**AGENDA**  
**BIRMINGHAM DESIGN REVIEW BOARD MEETING**  
**MUNICIPAL BUILDING-COMMISSION ROOM-151 MARTIN STREET**  
**WEDNESDAY – April 6, 2016**  
**\*\*\*\*\* 7:15 PM\*\*\*\*\***

**SUBJECT:** Design Review – 344 Hamilton Row

**SUBJECT:** Design Review – 1555 14 Mile Rd. – Kakos Market

CONCEPTUAL  
EXTERIOR  
BUILDING  
ELEVATIONS

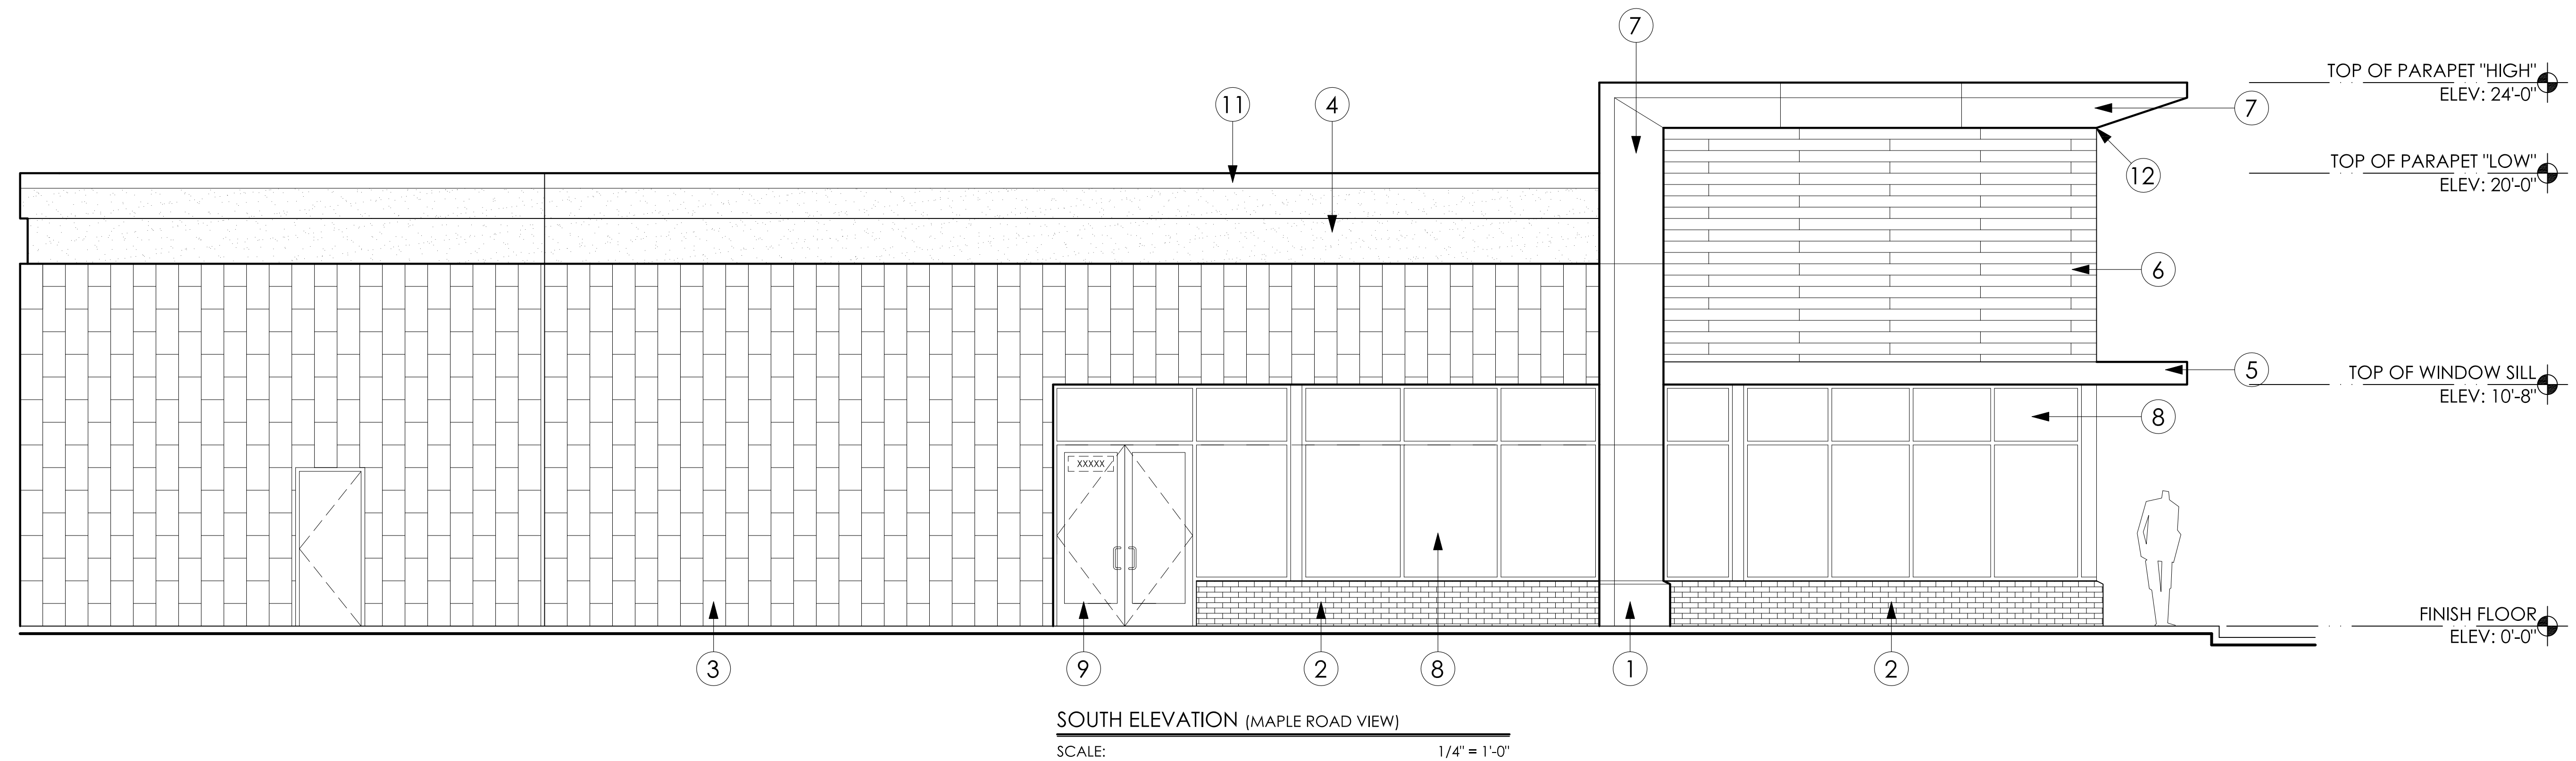
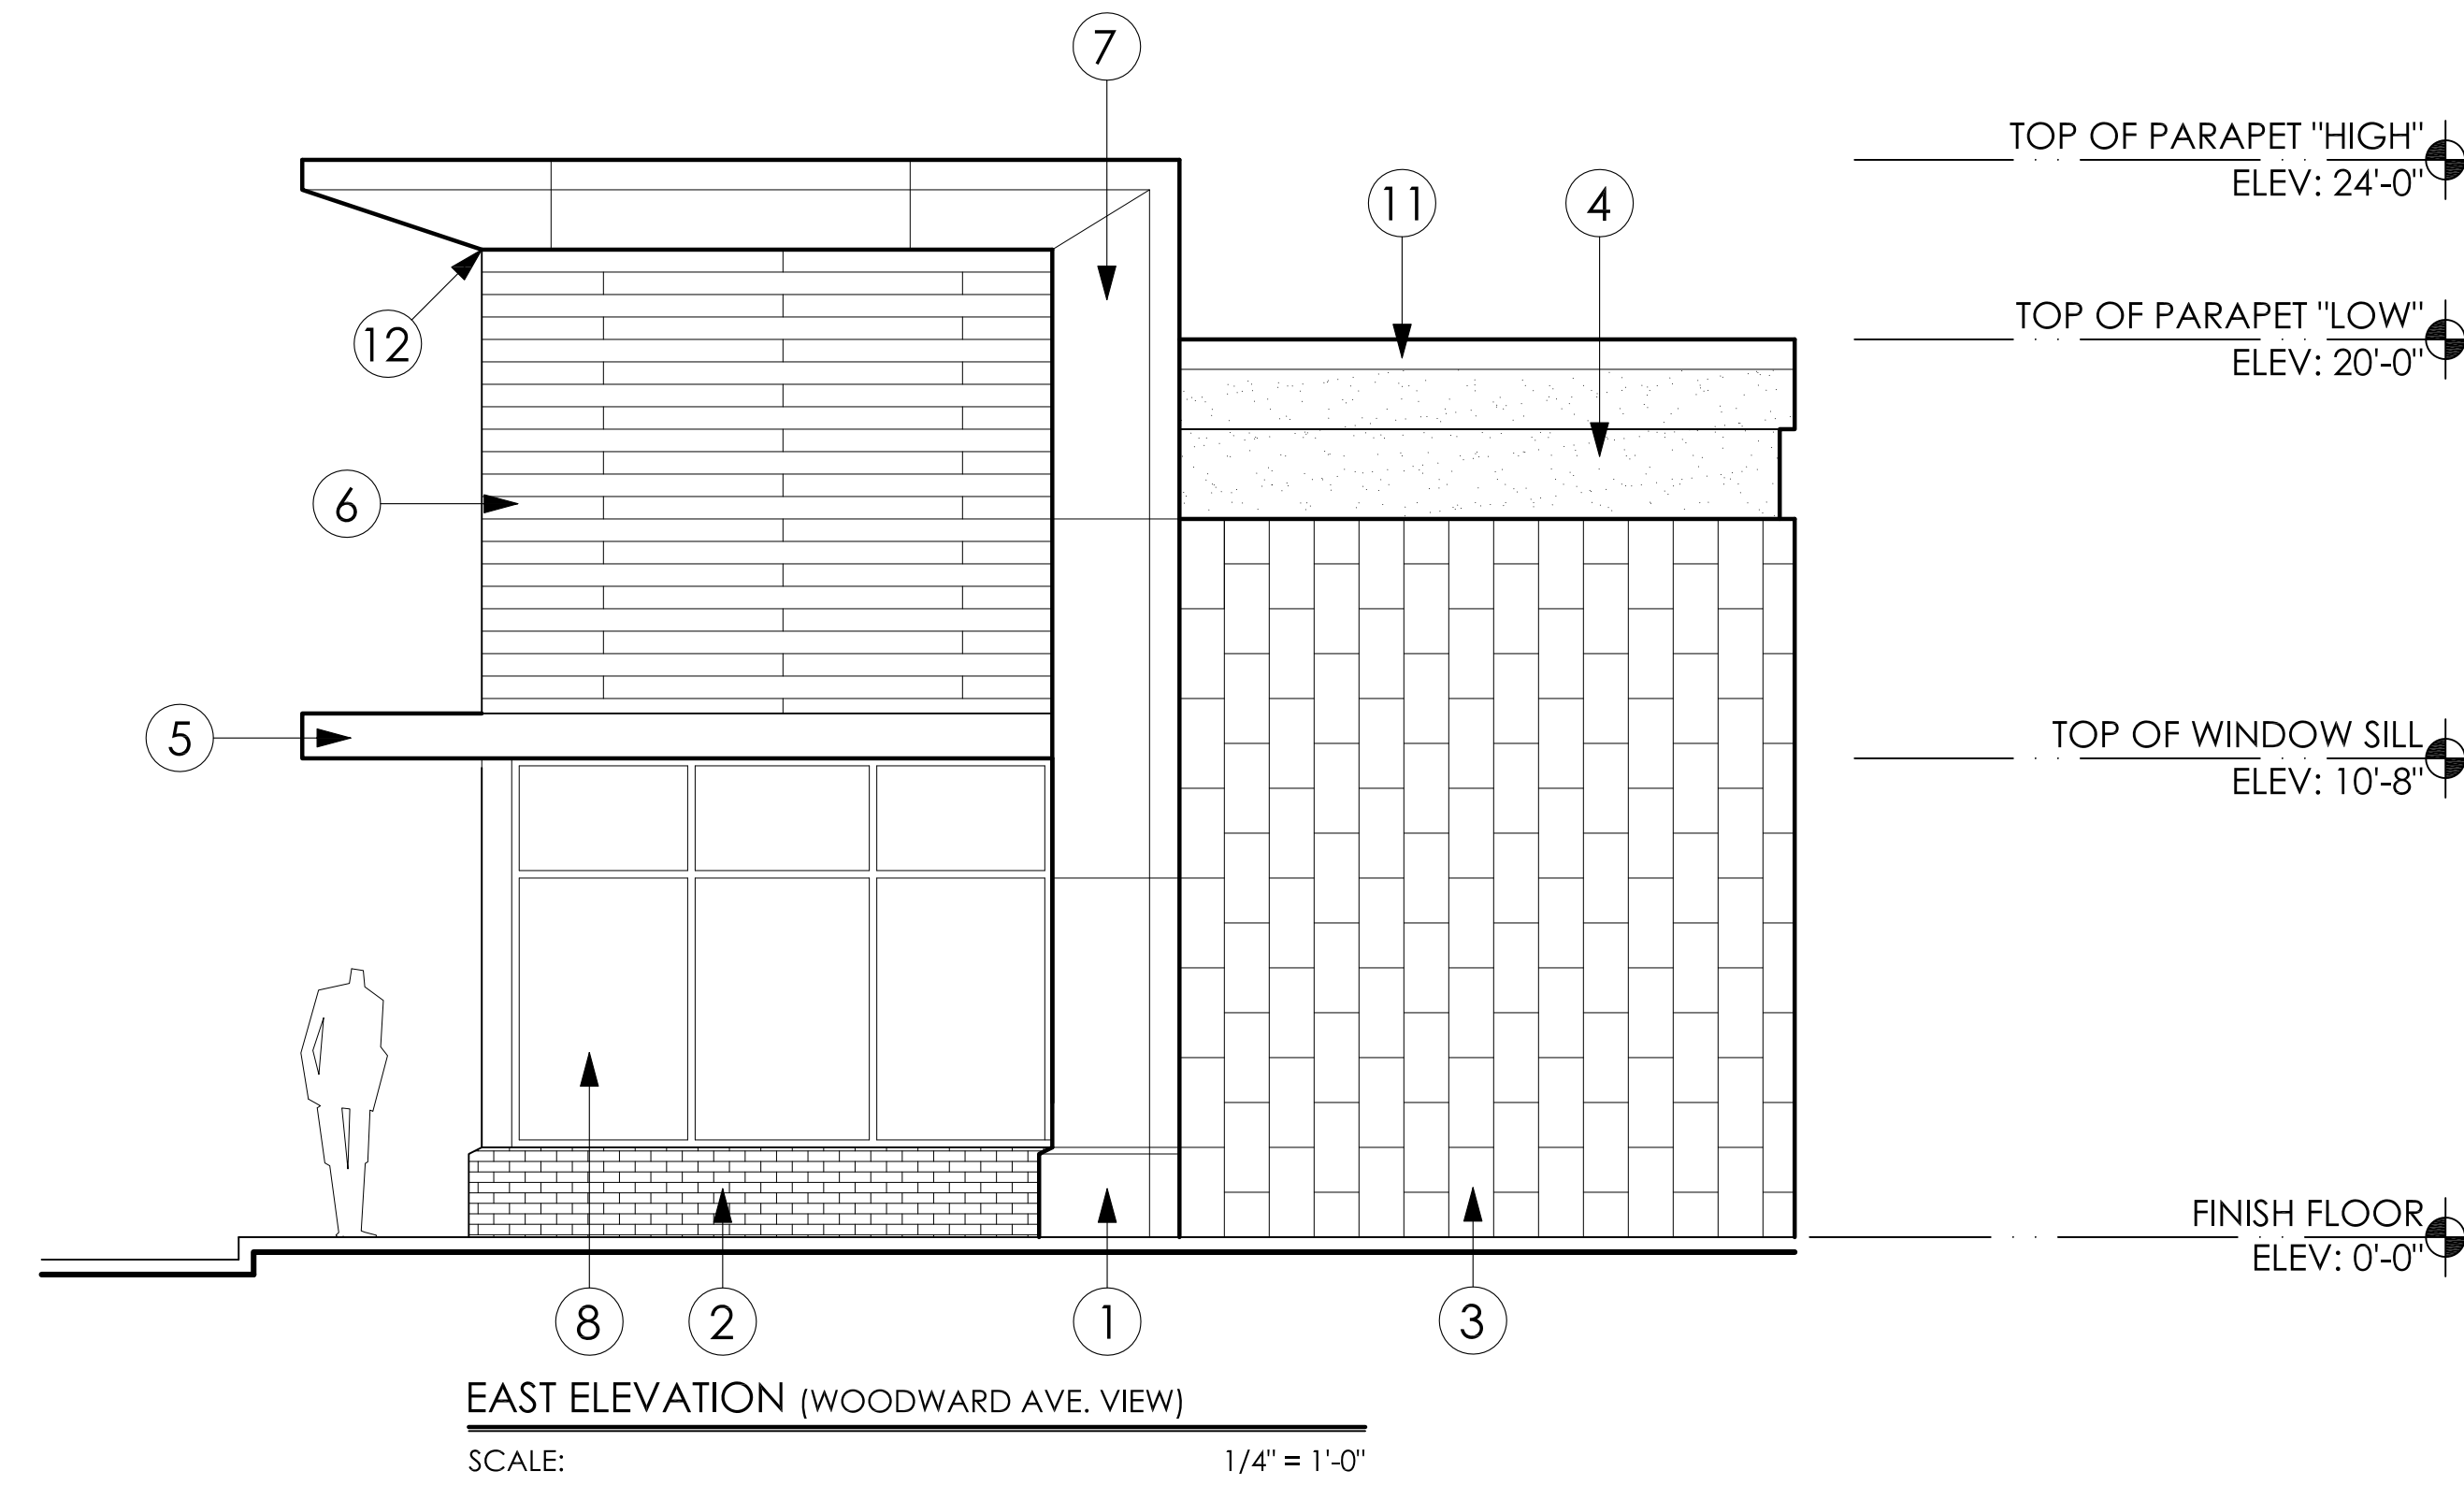
The applicant is proposing LED accent lighting to be mounted underneath the soffit of the “high” parapet. The lighting is rendered in red on the color elevations. **Typically the Board has not approved colored accent lighting on the outside of buildings. The Planning Division recommends that the red LED lighting be switch to white lights.**

1. The red LED lighting be switch to white lights
